National Highways Planning Response (NHPR 22-12) Formal Recommendation to an Application for Planning Permission

Council's Reference: PL/2023/09142

Location: Land at Junction 16 (M4), Swindon

National Highways Ref: NH/23/03529

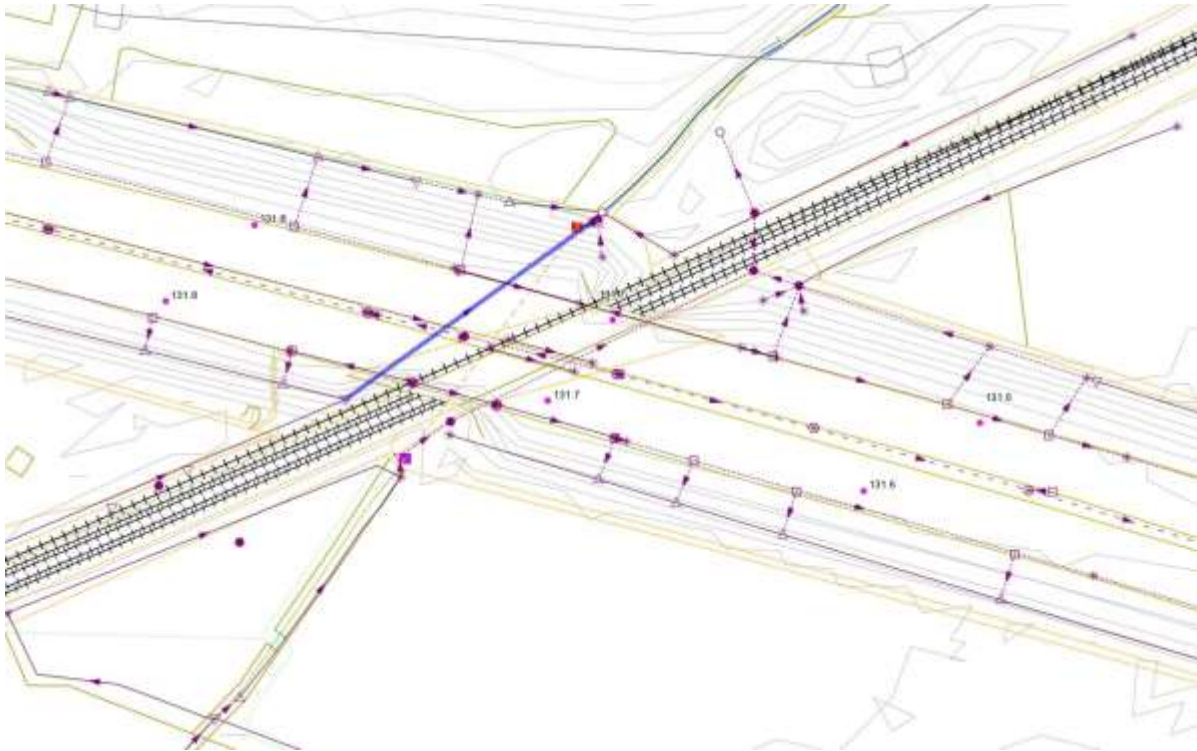
Whilst we are generally satisfied that the development doesn't directly affect National Highways M4 surface water drainage, the proposal to install a new roundabout along on the B4005 will impact the existing surface water drainage between the M4 J16 Spittleborough Roundabout and Hay Lane, to which National Highways currently has a lease title. This is indicated within the Conceptual SW Drainage Strategy drawing 107846-PEF-ZZ-XX-DR-CD-0504.

The applicant should therefore be made aware that changes to the B4005 surface water drainage may have an impact on the National Highways downstream M4 1200Ø Culvert at MP131.7+50m as indicated from our asset records below.

This will therefore need to be evidenced and addressed as part of the detailed drainage design for the development and associated access proposals. However, we consider that this matter could be addressed by a suitable pre-commencement planning condition although we are willing to consider any further information the applicant wishes to submit prior to determination.
